SEE II AIR FOIL INTERFERENCE

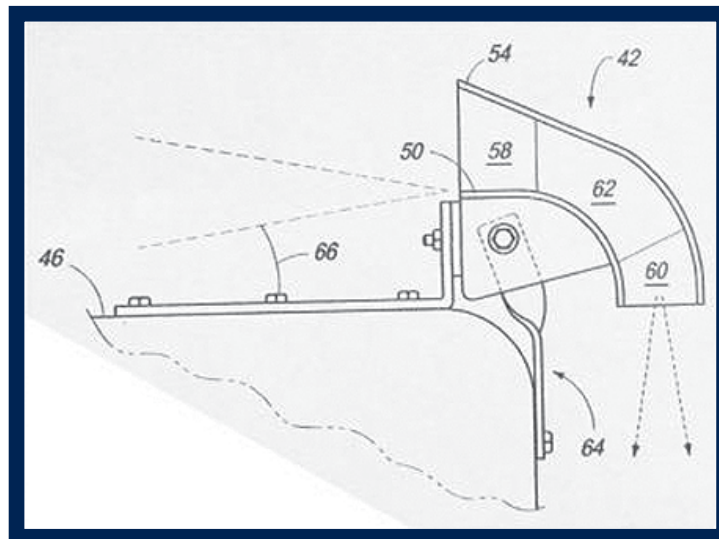
When installing First Light's Illuminated School Bus Sign (ISBS) on a school bus in conjunction with a See II Air Foil product, it is acceptable to shorten and drill a new hole in the flat surface of the twist brackets (item 64). The twist brackets can be modified, however must not be eliminated as they are essential to securing the air foil to the school bus. The twist brackets must be bolted to the steel rear cap of the bus as shown below and stated in the See II installation instructions (linked below).
